January 23, 2017

**Re: Comments on Revised Application for Marine Mammal Incidental Take Regulations for Geophysical Surveys in the Gulf of Mexico**

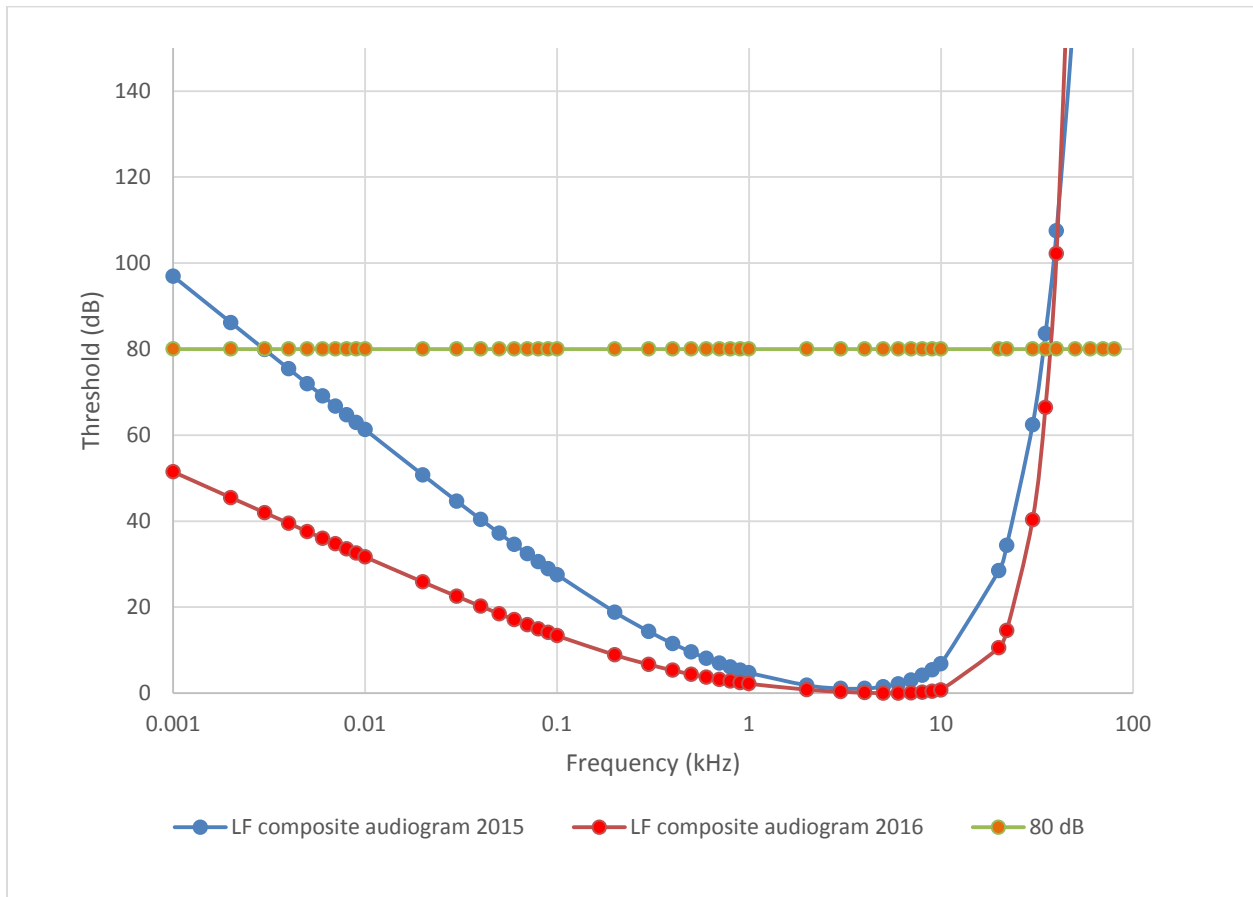
Figure 1. The consequence of the proposed changes to the LF cetacean modeled audiogram (in red) produce a hearing curve at the lowest frequencies that never approaches the 80 dB decrement from best hearing (in green) that NOAA had set as the upper and lower limiting frequencies of hearing (also a general mammalian metric of upper and lower hearing limits). The July 2015 modeled hearing curve (in blue), on the other hand, produces a crossing point with the 80 dB threshold at 3 Hz that provides a reasonable if generous lower limit of hearing.

In addition, on page 7 of the 2016 proposed changes, NOAA reviews four models for frequencies of best hearing and states that these models predict “thresholds within ~40 dB of best sensitivity as low as ~30 Hz and up to 25 kHz.” However, rather than use the predictions of these models, NOAA proposes a curve that predicts LF cetaceans can hear 30 Hz at 10 dB above best hearing, not 40 dB. Under NOAA’s model, whales could even hear sound at 10 Hz with only a 25 dB decrement from best hearing—which the best available science for baleen whale hearing modeling (*e.g.*, Houser et al. 2001; Cranford and Krysl 2015) and general mammalian hearing data strongly suggests is impossible. *See infra* footnote 8.

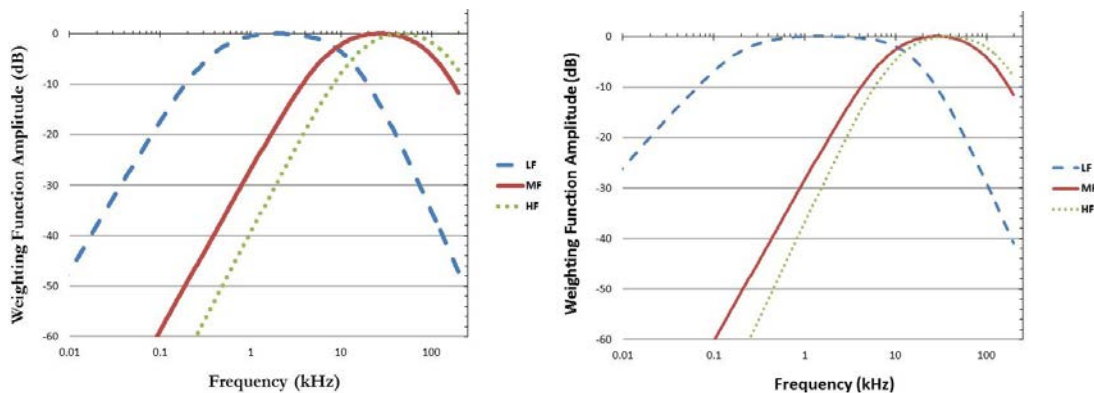
The impact of the new LF cetacean parameters is immediately obvious in our Figure 2 below, which compares Figure PC3<sup>7</sup> of the new 2016 criteria (*see right plot below*) with the curve depicted in NOAA 2015 Draft Guidance (page 12) (*see left plot below*). In contrast to the similar shapes of all the 2015 weighting functions, the new LF cetacean curve produces a biologically unrealistic, extended, and flattened curve.

Figure 2. The left plot shows initial July 2015 cetacean weighting functions: LF in dashed blue, MF cetacean in red and HF cetacean in dotted black. While the frequency range of best hearing for LF cetaceans is conservatively generous given uncertainties in the models, the slope of the weighting functions are all parallel, consistent with what is generally observed across mammalian hearing and weighting functions. The right plot shows that the modified March 2016 weighting functions not only create a much broader and obviously unrealistic span of best hearing (the flat upper part of the curve normalized to zero), but also provide a slope of increased weighting (decreased hearing ability) at the lower frequencies that is clearly out of alignment with the measured decrement of hearing acuity in all other marine mammals, as well as for mammals in general, including other LF specialist species.

NOAA’s proposed LF cetacean model also sharply deviates from data pertinent to other LF specialist mammals. For example, humans are LF hearing specialists that have a best hearing range of approximately 400 Hz to 16 kHz.<sup>8</sup> But, unlike the LF cetacean model proposed by NOAA, human hearing ability is 25 dB below best hearing at 200 Hz—not the 10 Hz value generated by NOAA’s proposed hearing curve. As another example, the kangaroo rat (another LF hearing specialist) has best hearing that starts to diminish at approximately 500 Hz. By 100 Hz, the kangaroo rat’s hearing threshold is at least 10 dB above best hearing, and at 20-30 Hz is
